CASCADE CHRISTIAN
 ATHLETIC FIELDS
 PUYALLUP, WA

DRAWING TITLE
IRRIGATION PLAN

SHEET NUMBER
L7.0

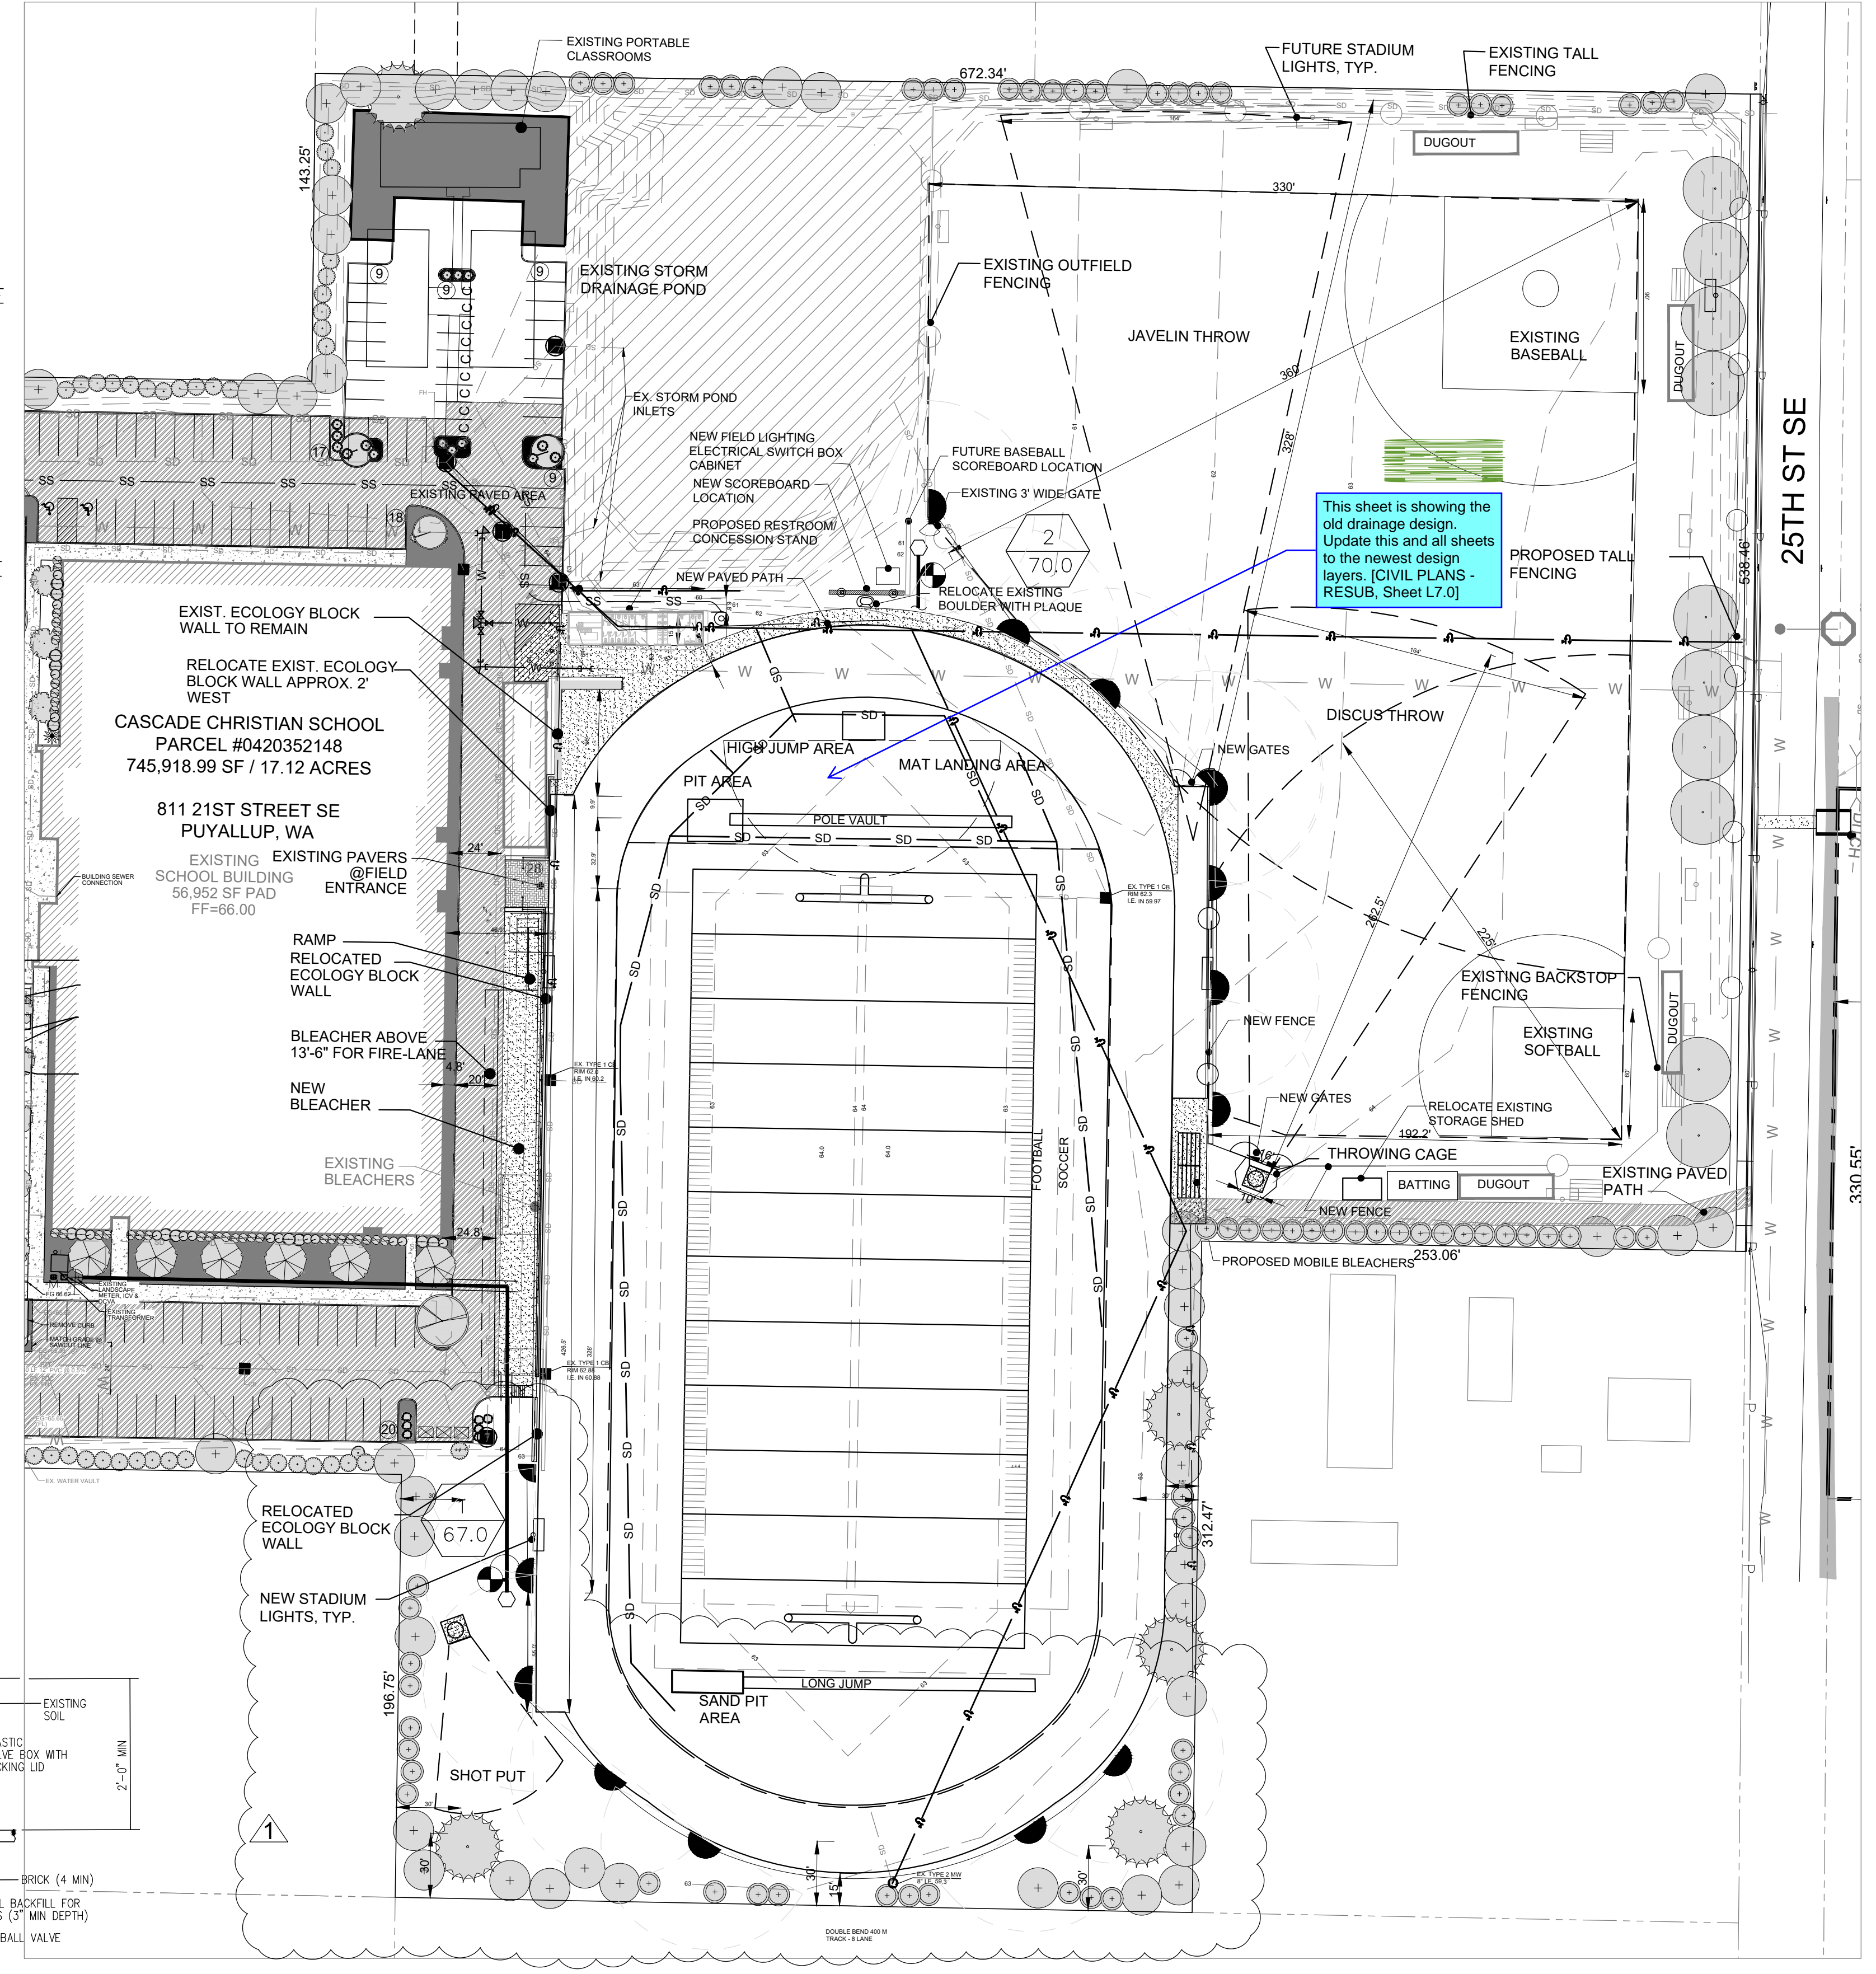
This sheet is showing the old drainage design. Update this and all sheets to the newest design layers. [CIVIL PLANS - RESUB, Sheet L7.0]
